15 July, 2012

Dear County Commissioners,

The purpose of this letter is to present some environmental, geological, and engineering concerns for your consideration as you and the Montana Department of Transportation guide the present studies and determine the future of the existing Maclay Bridge. I can offer some insight on these issues, with both a BA and an MS in geology from the University of Montana, as current owner and manager of a geological consulting business, and having lived near and observed Maclay Bridge since 1982. I was also involved in the 1992 to 1994 Environmental Assessment.

1961 air photo of Maclay Bridge (north to right of photo)

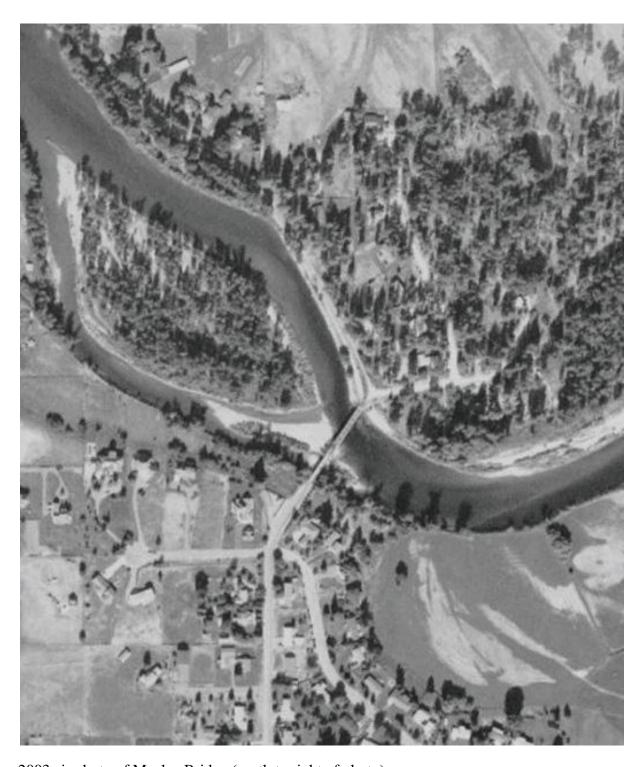
The 1935 photo may have been taken in June or July 1935 (the two stereo USFS air photos are marked 6-35 and 7-35); the 1961 photo was marked May 19, 1961; the 2003 air photo was marked July 1, 2003, and the 2011 photo was marked November 21, 2011. The online service GoogleEarth also provides free public access to historic Missoula area air photos for the time period from 2002 to 2011. This 9 year sequence can be viewed separately at GoogleEarth's website. The photos reveal that since the 1930's, there has been loss of river bank land on the west side of the river immediately downstream of the bridge. There has also been a development of a large whirlpool in this same area. In addition, there have been changes in the stream morphology upstream of the bridge. These include increased sand bar development and lengthening of the north (downstream) end of the island.
